ALERT SERVICE BULLETIN

429-14-15

Revision C, 22 February 2017

SUBJECT: GOODRICH EXTERNAL HOIST

Figure 1. Lower limit for the 600 lb capacity hoists

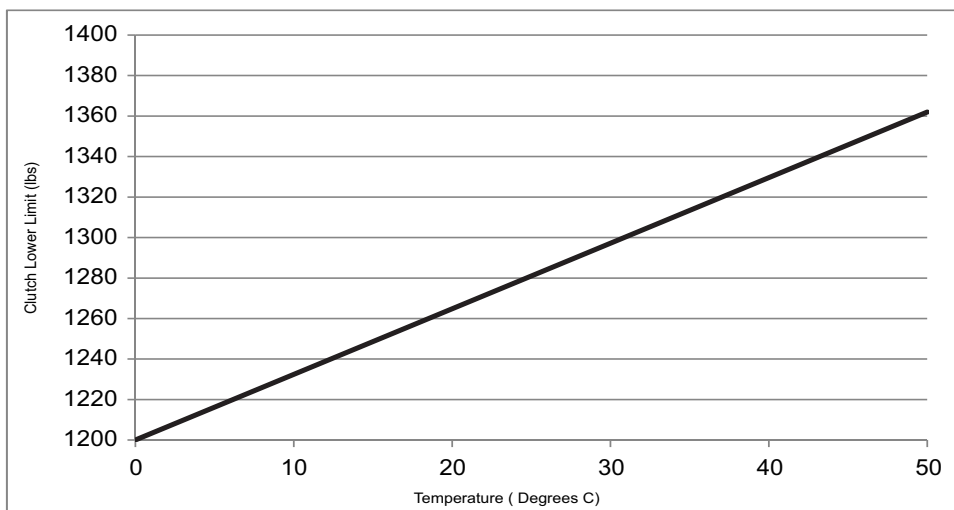
- a. If the test results indicate a value above the acceptable lower limits per Table 2, Figure 1 of the Goodrich ASB 44301-10-18, Revision 6, proceed with step 3.

- b. If the test results indicate a value below the acceptable lower limit per Table 2, Figure 1 of the Goodrich ASB 44301-10-18, Revision 6, remove the hoist from service before the next hoist operation.
